UNITED STATES PATENT AND TRADEMARK OFFICE

APPLICATION NO.	FILING DATE	FIRST NAMED INVENTOR	ATTORNEY DOCKET NO.	CONFIRMATION NO.
10/723,936	11/26/2003	Declan Somerville	1849012US1AP	9427
27542	7590	12/15/2005	EXAMINER	
SAND & SEBOLT AEGIS TOWER, SUITE 1100 4940 MUNSON STREET, NW CANTON, OH 44718-3615			DEVOTI, PAUL D	
			ART UNIT	PAPER NUMBER
			3637

Office Action Summary	Application No. 10/723,936	Applicant(s) SOMERVILLE, DECLAN	
	Examiner Paul Devoti	Art Unit 3637

DETAILED ACTION

Bukky (US Patent Number 6823814) Figure 1

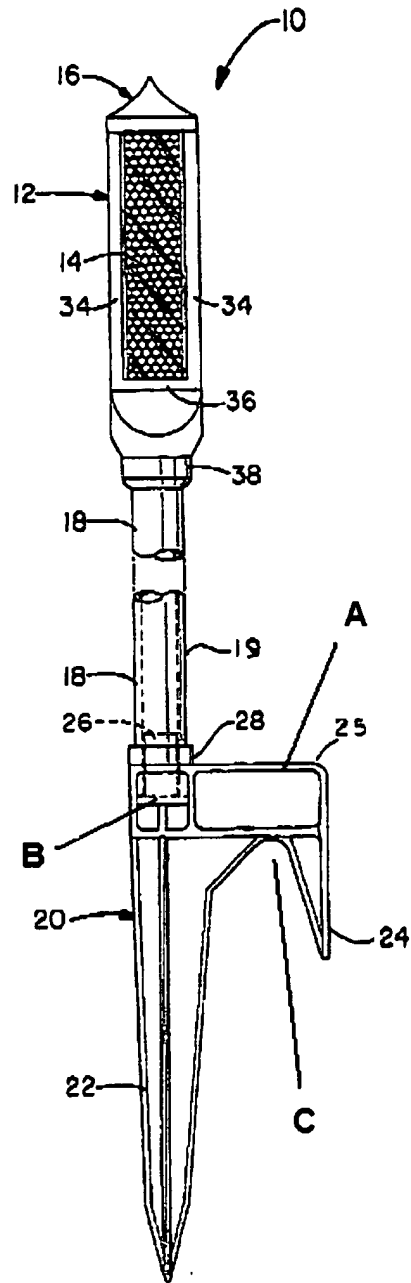
8. Claims 1, 2, 5, and 13 are rejected under 35 U.S.C. 102(b) as being anticipated by Bukky (US Patent Number 6823814). Bukky discloses a stake support with a lowermost portion (24) and an offset portion (25) connecting the lowermost portion to an uppermost portion (18) that is axially offset from the lowermost portion (24).

Additionally, an open platform directly above the lowermost portion (24) is disclosed by offset portion (25) that inherently serves as a hammer point when driving the lowermost portion into the ground. Regarding claim 2, Bukky discloses that the lowermost portion (24) is, in use, located below the ground surface, and the uppermost portion (18) is located above the ground surface. Regarding claim 5, the offset portion (25) extends at a right angle to the lowermost portion and includes parallel upper (A) and lower (B) frame members. Regarding claim 13, Bukky discloses a removal wedge consisting of an asymmetric notch (C) cut downwardly from the offset portion (25).

Blankemeyer et al. (US Patent Number 3732878) Figure 2

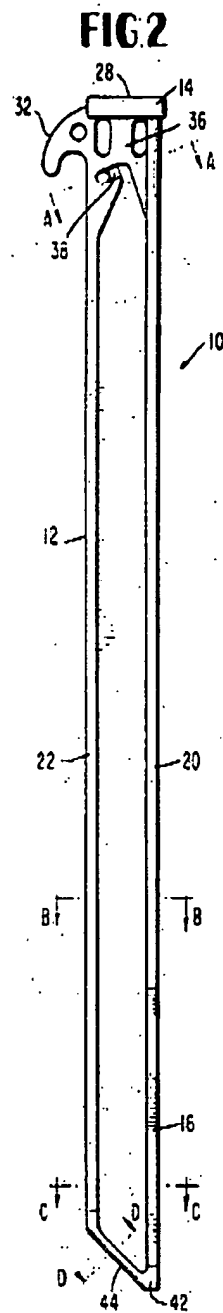
10. Claim 3 is rejected under 35 U.S.C. 103(a) as being unpatentable over Bukky in view of Blankemeyer et al. (US Patent Number 3732878). Bukky discloses everything previously mentioned, but does not teach an I-shaped member where a first side element extends further and is longer than a second side element, and the lower end of the lowermost portion forms a point. Blankemeyer et al., however, teaches an I-shaped member (12) where a first side element (20) extends further and is longer than a second side element (22) and forms a point (42). Therefore it would have been obvious to one having ordinary skill in the art at the time of invention to modify Bukky's stake device to include a lowermost portion with an I-shaped member, as taught by Blankemeyer to easily and securely drive the lowermost portion into the ground.

Jewett et al. (US Patent Number 6237289) Figure 8

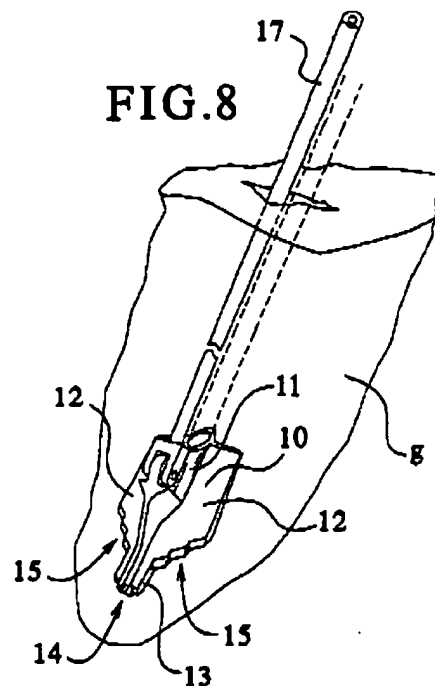
11. Claim 4 is rejected under 35 U.S.C. 103(a) as being unpatentable over Bukky in view of Blankemeyer as applied to claim 3 above, and further in view of Jewett et al. (US Patent Number 6237289). Bukky in view of Blankemeyer discloses everything previously mentioned, including a bottom edge extending slopingly between the first (20) and second side elements (22), but does not teach that the bottom edge includes an indented shoulder portion. Jewett et al., however, teaches a stake device having an indented shoulder portion (15) on the bottom edge. Therefore it would have been obvious to one having ordinary skill in the art at the time of invention to further modify Bukky's garden stake support, already modified by Blankemeyer, to include an indented shoulder portion on the bottom edge of the lowermost portion as taught by Jewett et al. to further facilitate penetration of the lowermost portion into the ground.

Kleinhesselink (US Patent Number 1555322) Figure 2

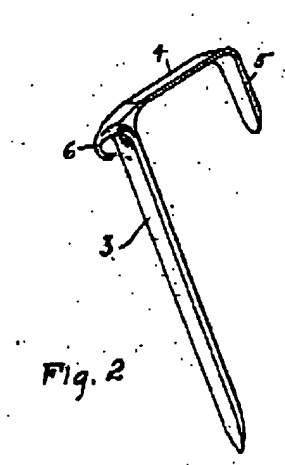
12. Claim 6 is rejected under 35 U.S.C 103(a) as being unpatentable over Bukky in view of Kleinhesselink (US Patent Number 1555322). Bukky discloses everything previously mentioned, but does not teach a curled tongue extension on the outer side of the lower frame member. Kleinhesselink, however, teaches a hook (6) on the outer side of the frame member (4) of a stake. Therefore, it would have been obvious to one having ordinary skill in the art at the time of invention to modify Bukky's stake support to include a curled tongue extension on the outer side of the frame member, as taught by Kleinhesselink to engage and hold an element such as a rope or pipe.

Despino (US D445054) Figure 6

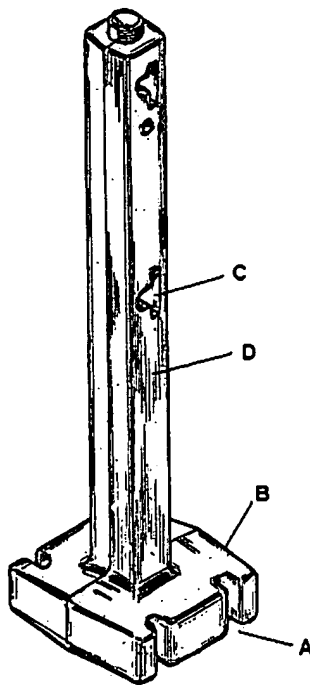
15. Claim 10 is rejected under 35 U.S.C. 103(a) as being unpatentable over Bukky in view of Fitzsimmons as applied to claim 8 above, and further in view of Despino (US D445054). Bukky discloses everything mentioned, but does not teach a notch cut into the first ledge and collar on opposing sides of the base member where the notches are axially aligned on either side of the stake base member. Despino, however, teaches a structure with notches (A) on the base member (B) and notches (C) on the upper

member (D), which are axially aligned on either side of the base member (B).

Therefore, it would have been obvious to one having ordinary skill in the art at the time of invention to modify Bukky's stake, already modified by Fitzsimmons, to include notches on the base member and collar on the upper member, as taught by Despino, to securely attach and hold a member such as a pipe.

Ferreira (US Patent Number 304683) Figures 5, 5a, and 8

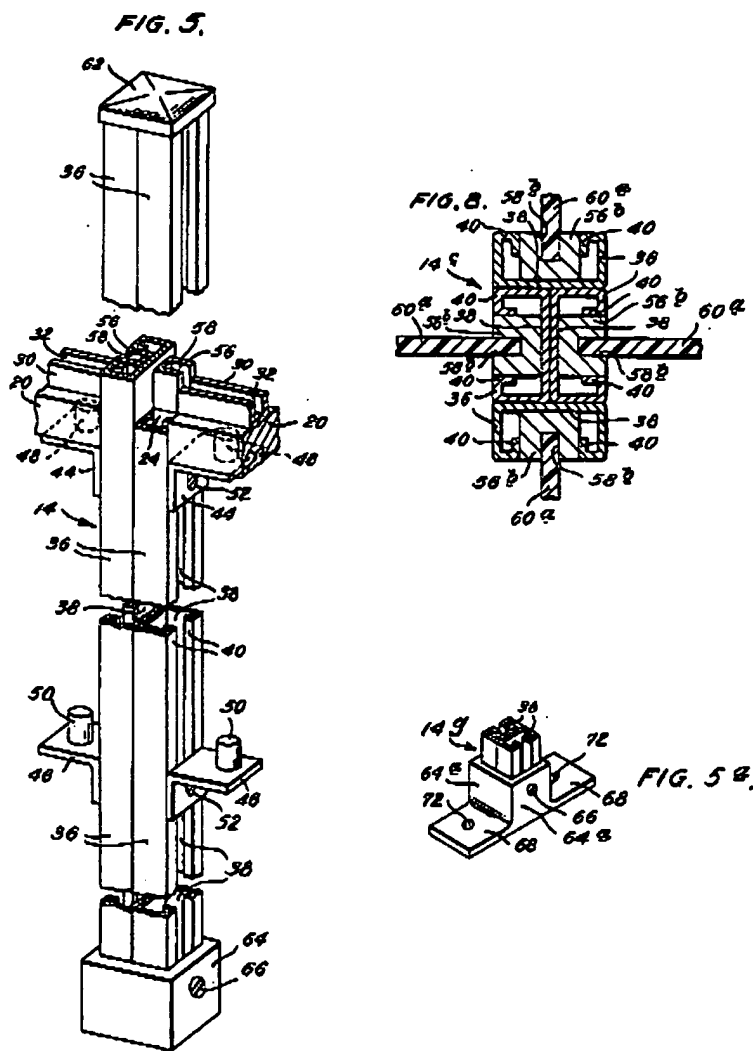
16. Claims 11 and 12 are rejected under 35 U.S.C. 103(a) as being unpatentable over Bukky in view of Fitzsimmons and Despino as applied to claim 10 above, and further in view of Ferreira (US Patent Number 3304683). Bukky in view of Fitzsimmons and Despino discloses everything previously mentioned, but does not teach an

interlocking section with an extrusion that in cross section takes the form of a back-to-back C-shaped element and that the interlocking section is formed of two interlocked back to back C-shaped elements forming a stable structure, where the second back to back C-shaped element is partially located within one back to back C-shaped element and is received in slots in the upper edge of the base member. Ferreira, however, discloses an interlocking upright section (36) in a base section (64), where the cross section of the interlocking section (36) takes the form of a back-to-back C-shaped element. Ferreira also teaches an interlocking section (36) formed of two interlocked back to back C-shaped elements, where the second back to back C-shaped element is located within one back to back C-shaped element (Figure 8) and is received in slots in the upper edge of the base section (64). Therefore, it would have been obvious to one having ordinary skill in the art at the time of invention to modify Bukky's stake, already modified by Fitzsimmons and Despino, to include an interlocking section with an extrusion that in cross section takes the form of a back-to-back C-shaped element and also an interlocking section (36) formed of two interlocked back to back C-shaped elements, where the second back to back C-shaped element is located within one back to back C-shaped element and is received in slots in the upper edge of the base section (64), as taught by Ferreira to provide a strong, secure, and easily manufactured interlocking section.
